ADDENDUM NO 01
CITY OF FAIRHOPE
To
BID NO. 036-11

SIDEWALK IMPROVEMENTS 2011
FOR THE PUBLIC WORKS DEPARTMENT

TYPICALS AND MISCELLANEOUS DETAILS

REFERENCE PROJECT NO	FISCAL YEAR	SHEET NO
STPTE-TE09(978)	2011	revised 2B

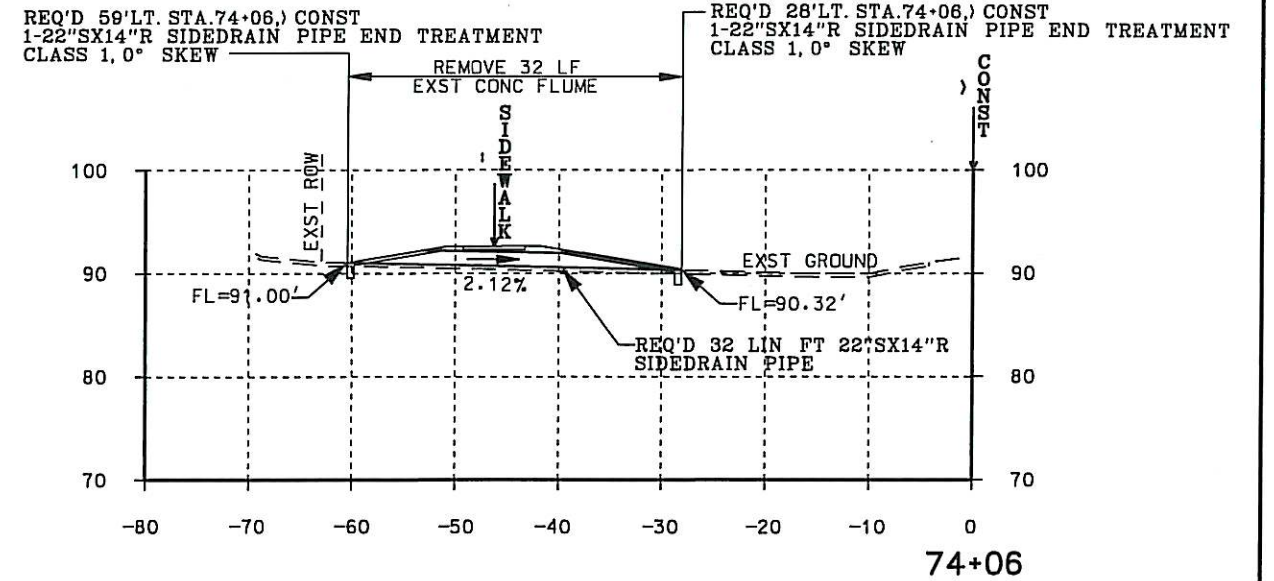
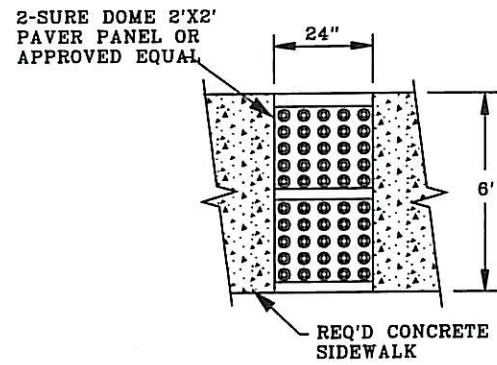
A pay item has been added to the Bid Proposal form for the installation of tactile warning mats. Contractor shall remove Sheet 2B from the construction drawings and replace with attached revised Sheet 2B.
